Access Compliance Report

Public Rights-of-Way

(Curb Ramps)

Intersection ID: 3083	Main Street: LOGANVILLE_DR	Cross Street: PANTHERSVILLE_DR	Location: NE
ADA ID: 781EA7EF6B3E	Ramp Type: Perp	Initial Pass/Fail: Fail	Overall Compliance: No
Codes/Mitigation Info/Possible Solution		Field Measurements/Component Compliance	
Severity Score: 61.25

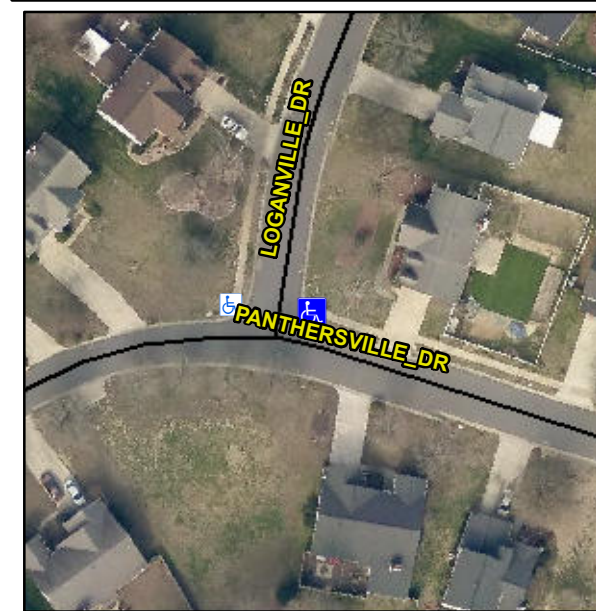
R304.5.1, R304.2.2, R304.5.3

Compliance	Description	Data	Compliance	Description	Data
N/A	Ramp Length (in)	96.5	No	Ramp Slope (%)	12.2
No	Ramp Width (in)	30.0	No	Ramp XSlope (%)	4.1
N/A	Flare Type LT	N/A	N/A	Flare Type RT	N/A
N/A	Flare Slope LT (%)	N/A	N/A	Flare Slope RT (%)	N/A
N/A	Flare Traversable LT?	N/A	N/A	Flare Traversable RT?	N/A
N/A	Landing Length (in)	N/A	N/A	DWS Provided?	N/A
N/A	Landing Width (in)	N/A	N/A	DWS Contrast?	N/A
N/A	Landing Slope (%)	N/A	N/A	DWS Length (in)	N/A
N/A	Landing X Slope (%)	N/A	N/A	DWS Full Width?	N/A
N/A	Landing Curb? (Y/N)	N/A	N/A	DWS Offset (in)	N/A
N/A	Shared Landing?	N/A			
N/A	Gutter Ponding?	N/A	N/A	Gutter Slope (%)	N/A
N/A	Gutter Lip Ht (in)	N/A	N/A	Gutter X Slope (%)	N/A
N/A	Painted X Walk1?	No	N/A	Painted X Walk2?	N/A
	X Walk 1 Direction	To W		X Walk 2 Direction	N/A
N/A	X Walk 1 Width (in)	N/A	N/A	X Walk 2 Width (in)	N/A
	X Walk 1 Slope (%)	0.6		X Walk 2 Slope (%)	N/A
	X Walk 1 X Slope (%)	3.8		X Walk 2 X Slope (%)	N/A

Remove & Replace Entire Ramp.
